## Product Change Notification / JAON-09QXBX743

CCB 5010.002 Final Notice: Qualification MTAI as an additional assembly site for selected LAN8720A-CP-ABC, LAN8720AI-CP-ABC, LAN8720A-CP-TR-ABC, and LAN8720AI-CP-TR-ABC catalog part numbers (CPN) available in 24L QFN (4x4x0.9mm) package.

**CCB 5010.002**  
**Pre and Post Change Summary**  
**PCN#: JAON-09QXBX743**

# Lead frame comparison

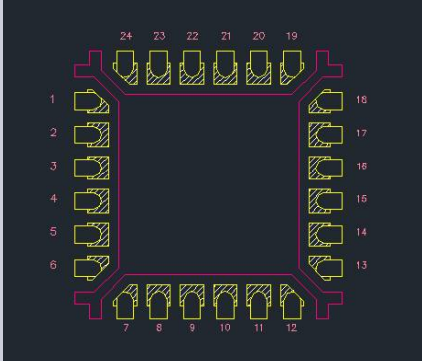
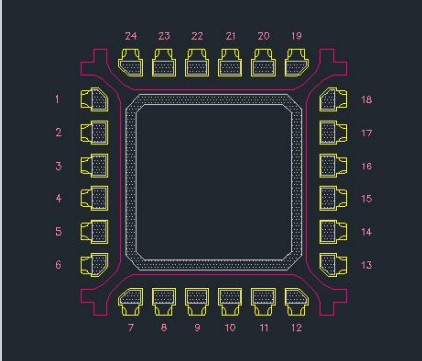
Lead Frame material	A194
Lead Frame Paddle size	106x106 mils

Lead Frame material	A194
Lead Frame Paddle size	110x110 mils
